# STAFF REPORT

SUBJECT: H-2021-0063 – Outer Banks Subdivision/The 10 Meridian

### I. PROJECT DESCRIPTION

### A. Preliminary Plat (date: 09/22/2021) & Phasing Plan

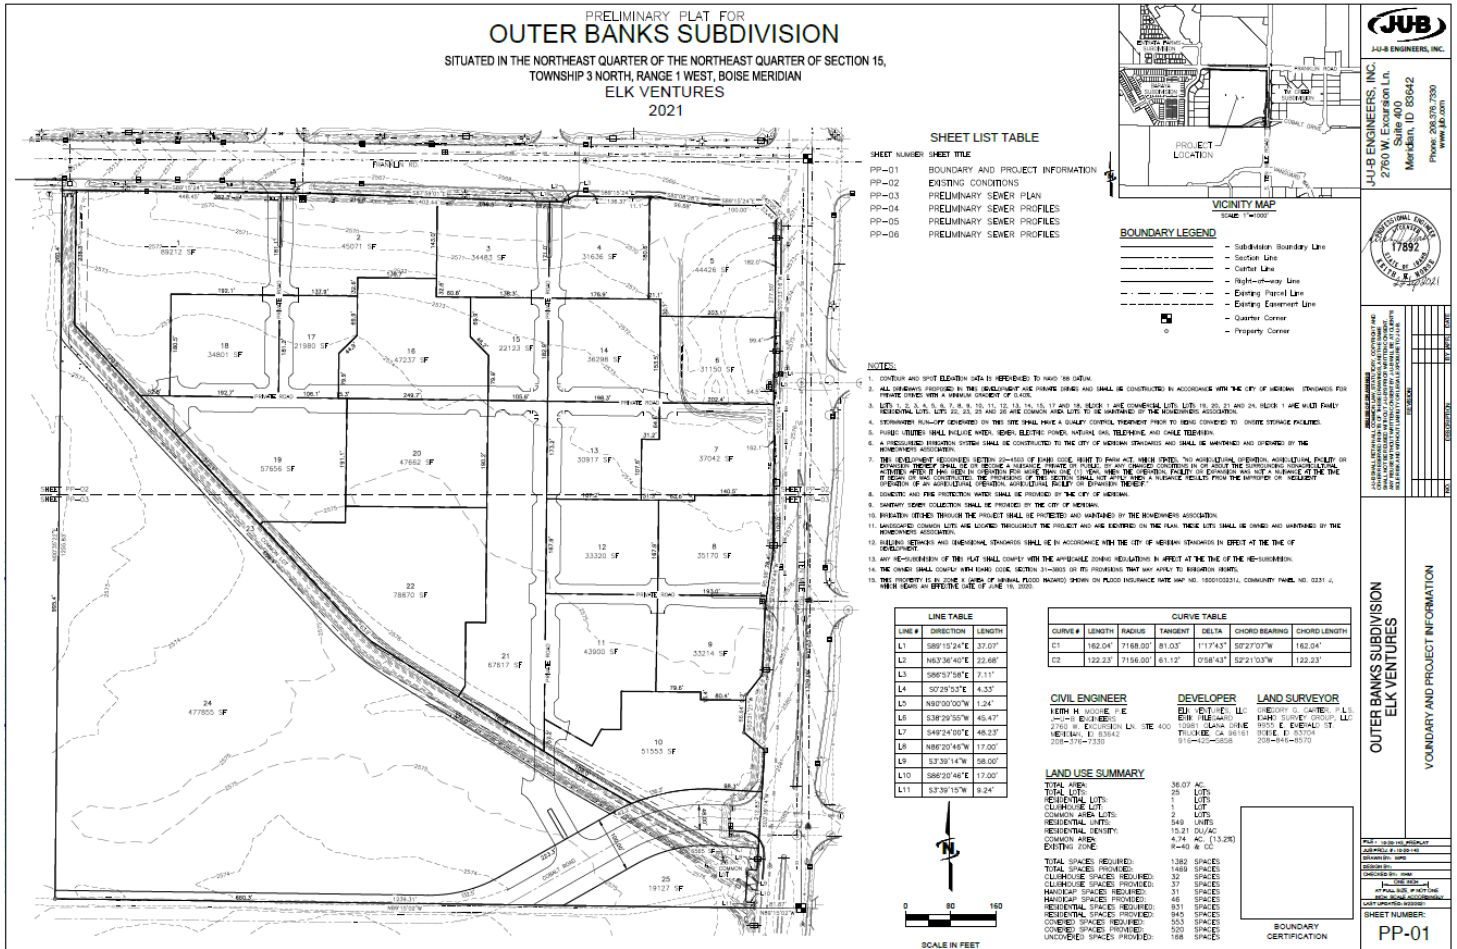
Street buffer landscaping is required to be provided with the subdivision in accord with the widths specified in UDC [Table 11-2A-8](#) for the R-40 zoning district and [11-2B-3](#) for the C-C zoning district based on the street classification and planted in accord with the standards listed in UDC [11-3B-7C](#). A landscape plan was submitted for the proposed subdivision landscaping, included in Section VIII.B.

Required street buffer widths are as follows: 25-feet along W. Franklin Rd., an arterial street; 35-feet along S. Ten Mile Rd., an arterial street and entryway corridor; and 20-feet along W. Cobalt Dr., a collector street. The street buffers along Franklin Rd., Cobalt Dr. and the portion along Ten Mile Rd. north of the driveway access nearest the intersection appear to meet the minimum width standard; **however, the portion along Ten Mile Rd. south of the driveway nearest the intersection does not meet the minimum width standard and needs to be widened (see UDC [11-3B-7C.1a](#) for measurement standards); the plans should be revised accordingly. A common lot or a permanent**

**dedicated buffer for the street buffers should be depicted on the plat and should be maintained by the property owner or business owners' association in accord with UDC 11-3B-7C.2b.**

- c. Depict the Irrigation District's easement for the Kennedy Lateral.
  - d. The street section for Cobalt Dr. shall include (2) 11-foot wide travel lanes, 6-foot wide bike lanes, 8-foot wide parallel parking, curb, gutter, 8-foot wide planter strips (i.e. tree lawn/parkway) and detached 6-foot wide sidewalks consistent with Street Section D in the [TMISAP](#) (see Pg. 3-21). Parallel parking shall be located to the west of the horizontal curve for Cobalt Dr. and be located beyond the sight distance required for the access proposed on Cobalt Dr. as required by ACHD.

- f. Provide a minimum 8-foot wide tree lawn/parkway along S. Ten Mile Rd. in accord with the TMISAP.
  - g. Dry utilities shall be located at the back of the curb in the dry utilities corridor along S. Ten Mile Rd. and W. Franklin Rd. in accord with Street Sections A and B in the TMISAP (pg. [3-22](#)).

## B. Cobalt Road Plan and Road Construction & Cooperative Development Agreement

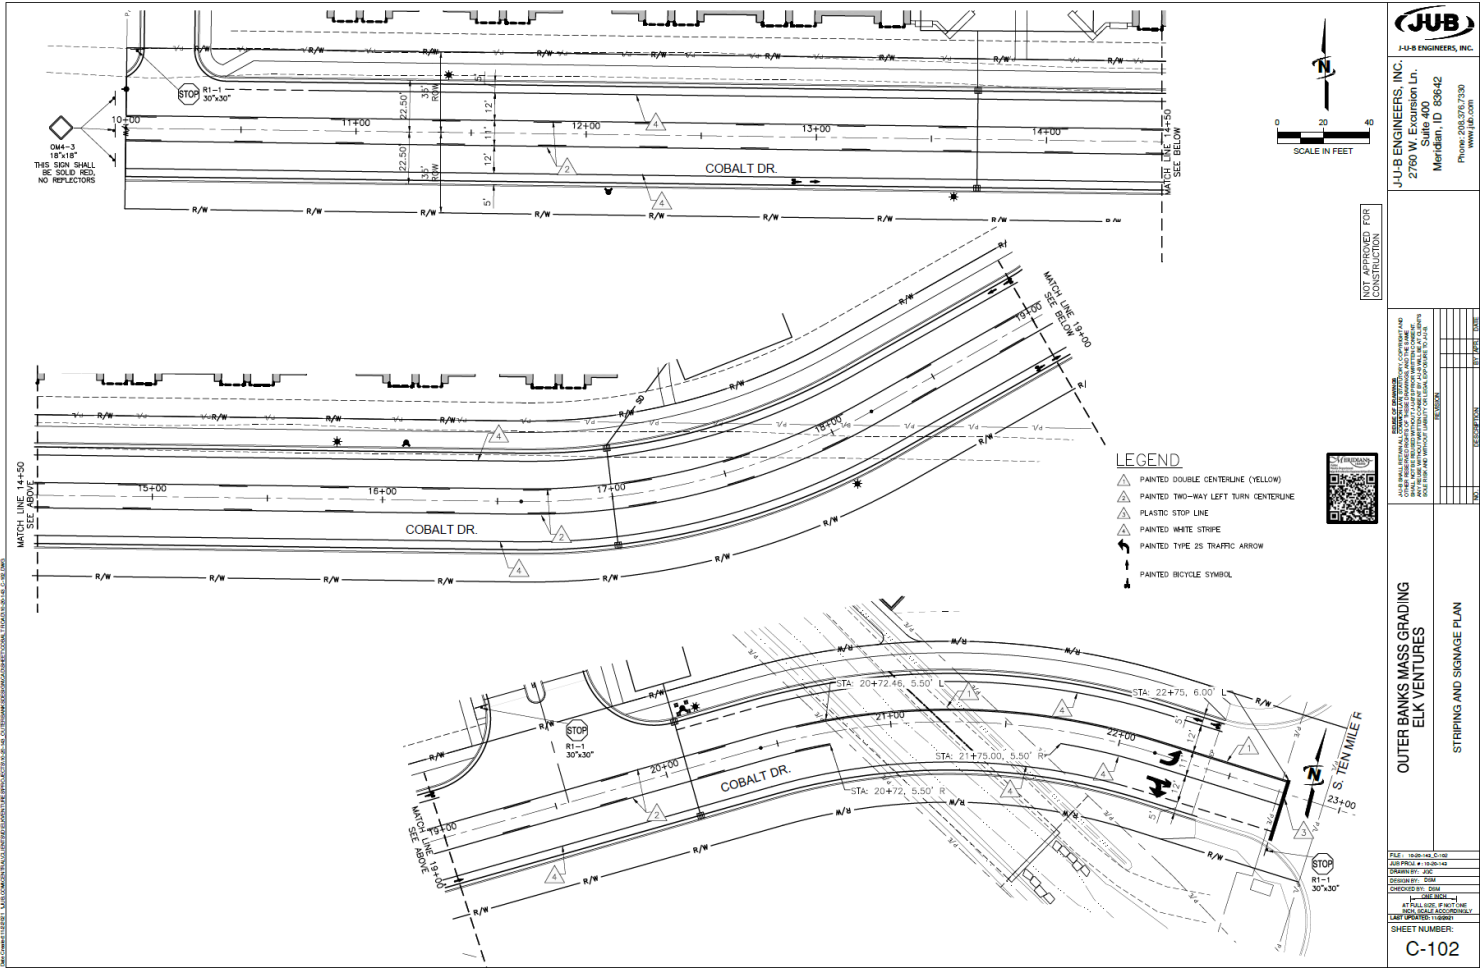
Cobalt Dr. is proposed to be extended from Ten Mile Rd. to the west boundary of the site within 70 feet of ROW (46-foot back of curb to back of curb, see Section VIII.B). Cobalt will be partially on this site and partially on the abutting property to the south and will include a bridge across the Kennedy Lateral.

As noted above in Section V, Cobalt is designated as Street Section D, a residential collector street, on the Street Section Map in the TMISAP. As such, it should have (2) 11-foot wide travel lanes, 6-foot wide on-street bike lanes and 8-foot wide parallel parking within 50-foot curb to curb, 8-foot wide planter strips (i.e. tree lawn/parkway) and detached 6-foot wide sidewalks as shown on the diagram above. The proposed street section reflects 3-lanes (2-travel lanes with a center turn lane), 3.5-foot wide bike lanes, curb, gutter, 7-foot wide planter strips and 5-foot wide detached sidewalks.

ACHD's staff report states if parallel parking is required by the City, it should be located to the west of the horizontal curve for Cobalt Dr. and be located beyond the sight distance required for the access proposed on Cobalt Dr. (parking is not allowed to be striped on ACHD roadways). Bike lanes are required to be a minimum of 6-feet wide. **Staff recommends Cobalt is constructed in accord with Street Section D in the TMISAP, as recommended by ACHD.**

### C. Landscape Plan for Preliminary Plat (dated: 9/16/21)

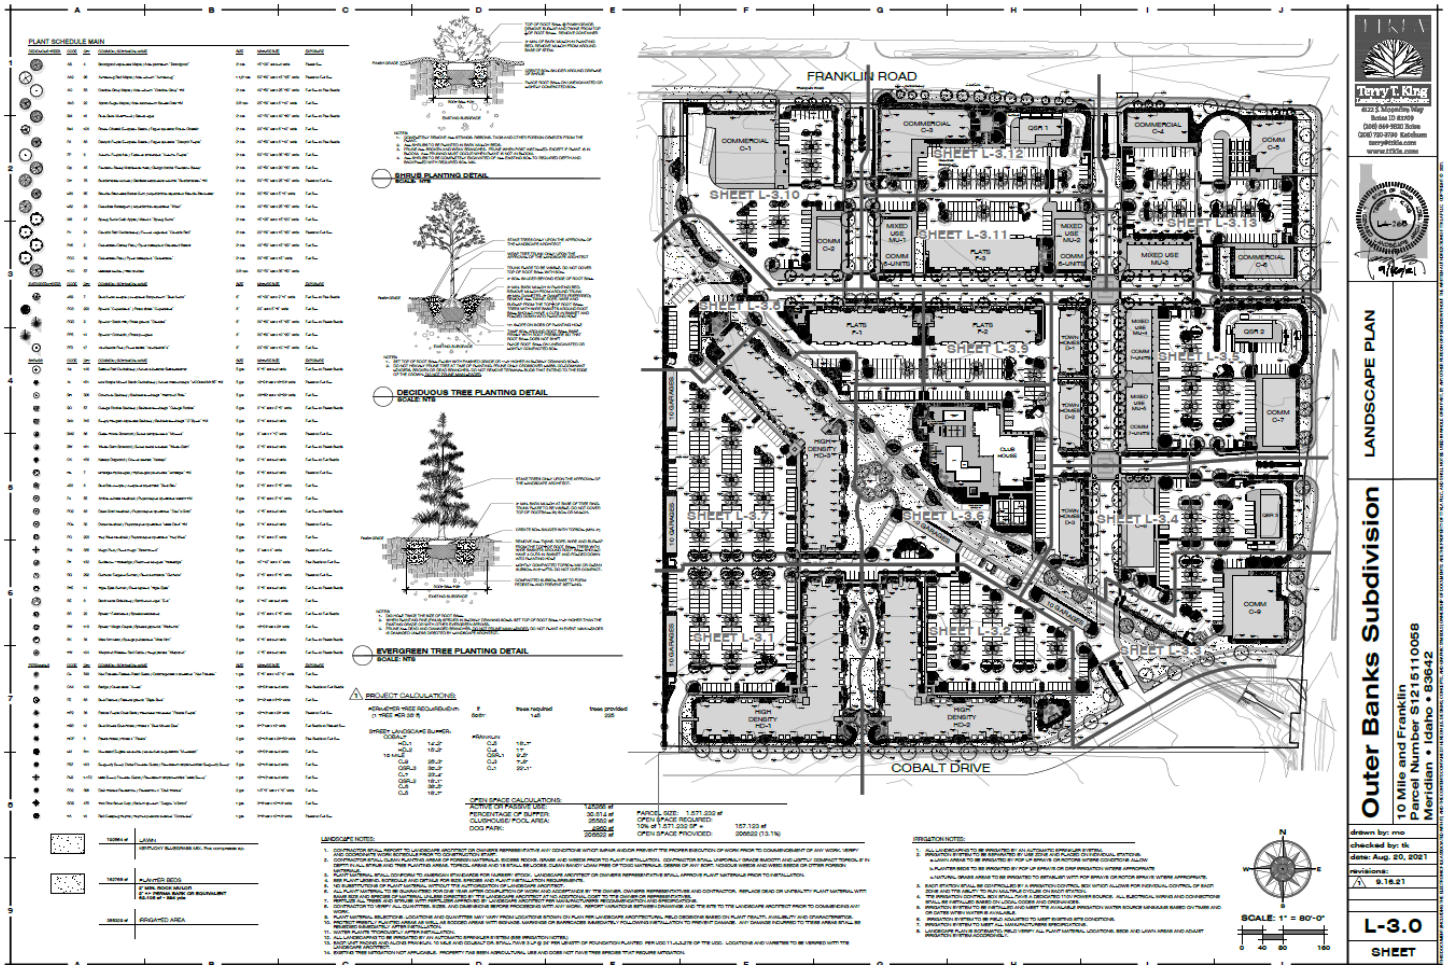
**The number of trees proposed in buffers meets the minimum standard; however, a mix of trees and shrubs with lawn or other vegetative groundcover is required – shrubs should be added to the buffers in accord with UDC 11-3B-7C.3a. Tree lawns need to be provided along Franklin Rd., Ten Mile Rd. and Cobalt Dr. consistent with the TMISAP where not proposed.**

Landscaping is required along all pathways per the standards listed in UDC 11-3B-12C, which requires a *mix* of trees, shrubs, lawn, and/or other vegetative ground cover – a minimum of one (1) tree per 100 linear feet of pathway is required. **The landscape plan should be revised accordingly to include shrubs along the pathway.**

**A calculations table should be included on the landscape plan submitted with the final plat application that demonstrates compliance with the above standards.**

3. The landscape plan included in Section VIII.C shall be revised as follows:
  - a. Include shrubs (along with the trees and lawn or other vegetative groundcover) in the proposed street buffers as set forth in UDC [11-3B-7C.3a](#) and along pathways as set forth in UDC [11-3B-12C.2](#).

- c. Include a calculations table on the landscape plan that demonstrates compliance with the landscape standards for street buffers listed in UDC [11-3B-7C.3b](#); common open space areas listed in UDC [11-3G-3E.2](#); and pathways listed in UDC [11-3B-12C](#).

## D. Site Plan for Multi-Family Portion of Development (date: 8/23/2021)

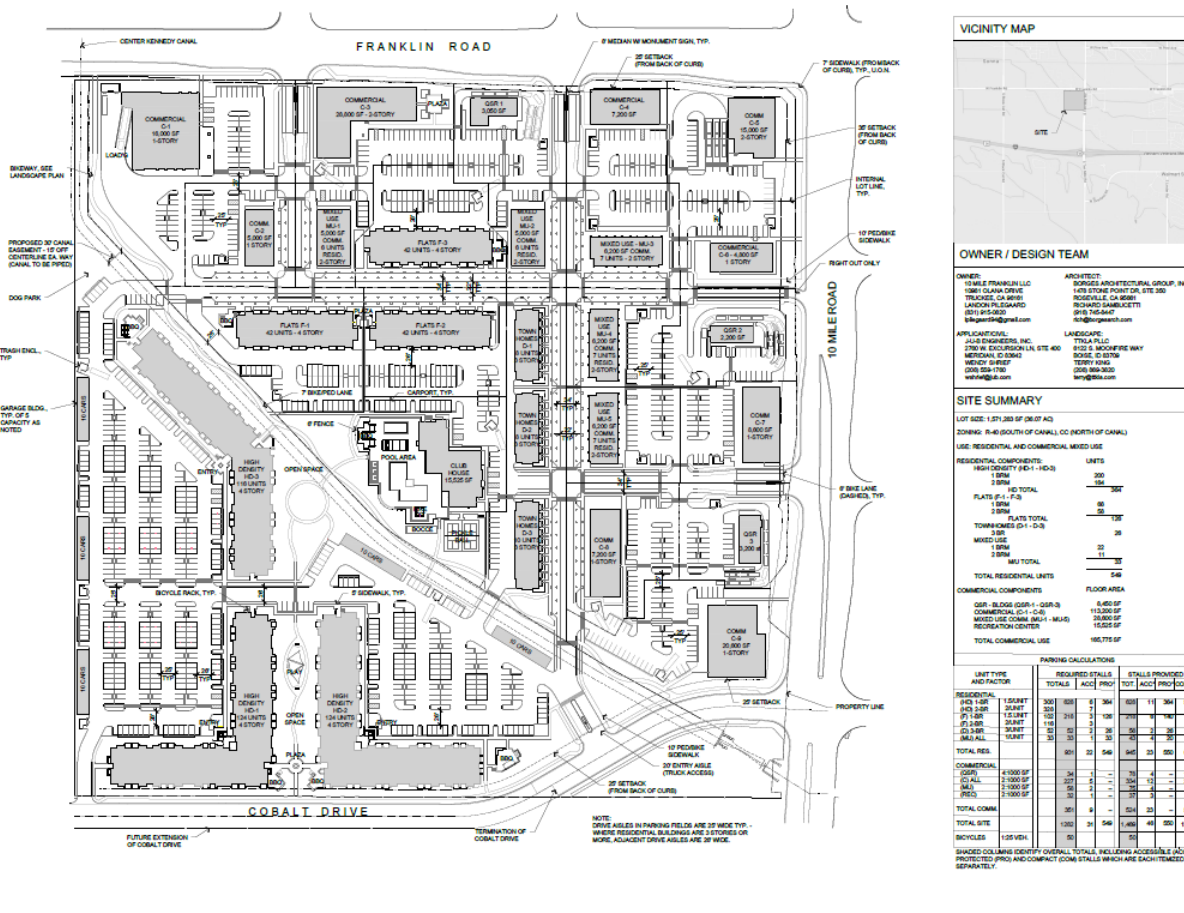
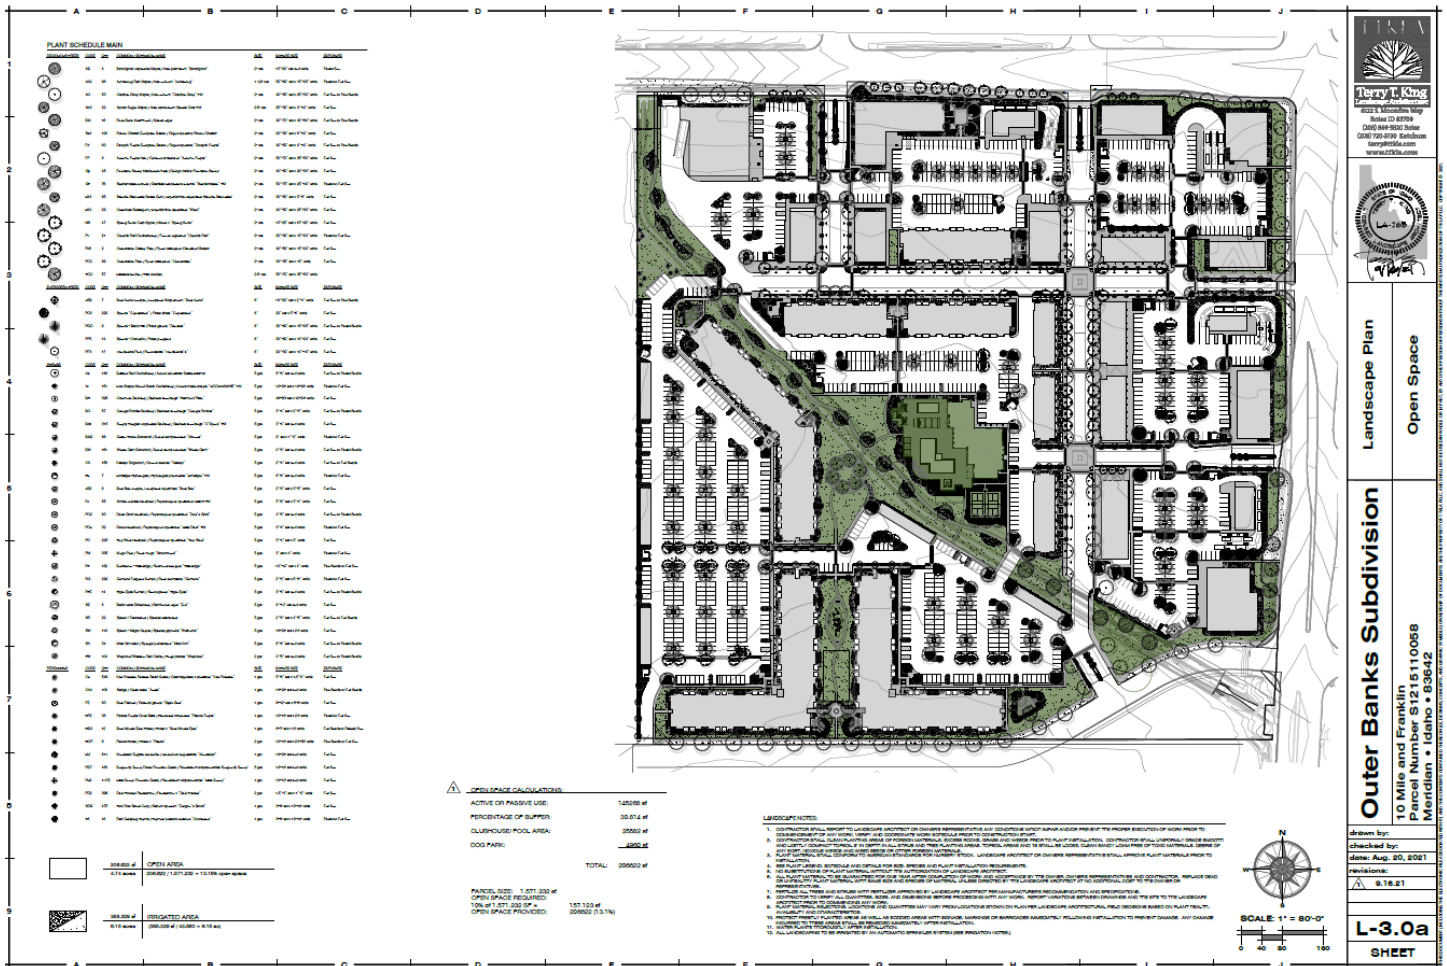
1. Buildings shall provide a minimum setback of ten feet (10') unless a greater setback is otherwise required by this title and/or [title 10](#) of this Code. Building setbacks shall take into account windows, entrances, porches and patios, and how they impact adjacent properties. *Flats F-3 and the garages along the west boundary do not meet the minimum setback requirement of 10'; revise accordingly.*

- c. A central mailbox location, including provisions for parcel mail, that provide safe pedestrian and/or vehicular access. *Depict on site plan.*
  - d. A directory and map of the development at an entrance or convenient location for those entering the development. (Ord. 18-1773, 4-24-2018) *Depict on site plan.*

***The site plan submitted with the Certificate of Zoning Compliance application should depict the location of these items in accord with this standard.***

- b. Depict the locations of the property management office, maintenance storage area, central mailbox location (including provisions for parcel mail, that provide safe pedestrian and/or

- d. The configuration/location of the Flats F-3 building and the garage structures along the project's west boundary need to be revised to comply with the minimum setback requirement of 10-feet in UDC [11-4-3-27B.1](#); the configuration of Lot 16 may be revised on the plat in order for the building (i.e. F-3) to meet the required setback.

- f. Include a detail of the fire pit, BBQ's, public art and children's play structure.
  - g. A minimum of 902 off-street parking spaces shall be provided as proposed, including 530 covered spaces. Compact stalls are discouraged but may be used for any parking above the number of required spaces per UDC [11-3C-5A.6](#). *This does not include the 31 spaces required for the clubhouse, vertically integrated/mixed use or commercial uses.*
